Final Technical Review (CESIR)

1.4 MW PV Generating Station

**Frey Rd
Macedon, NY 14502**

File # 13185

5. Transformer

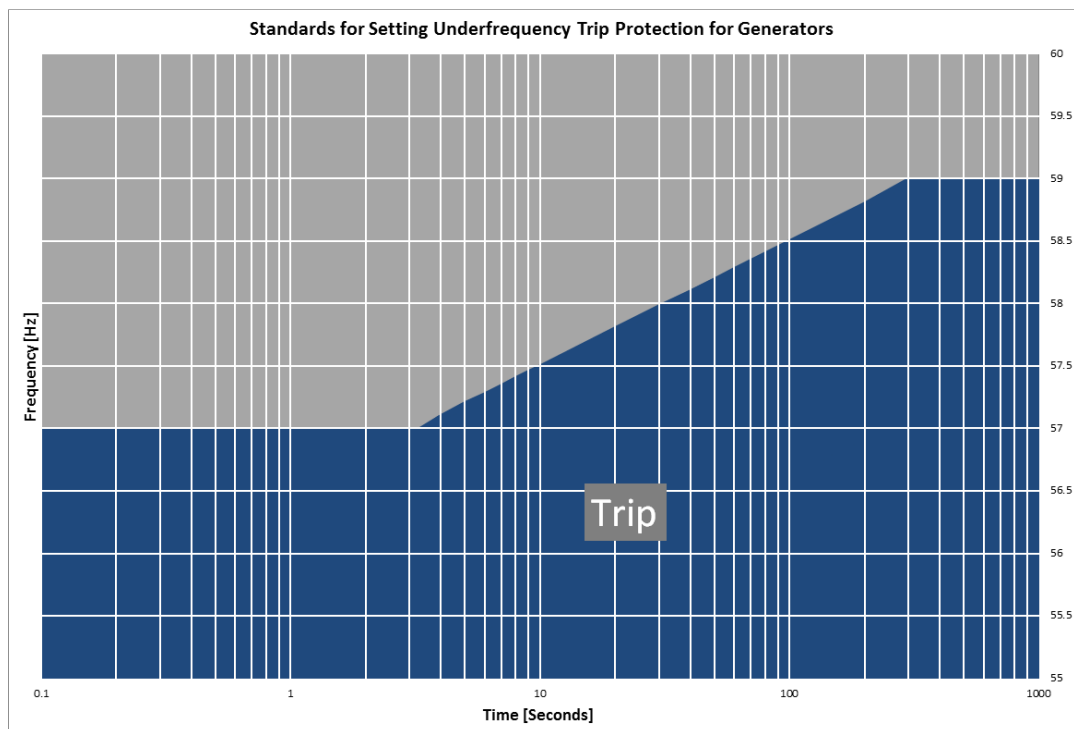
The proposed transformer that is being installed has a 12.47 kV Grounded Wye connection on the high side in order to interconnect with the RGE distribution feeder.
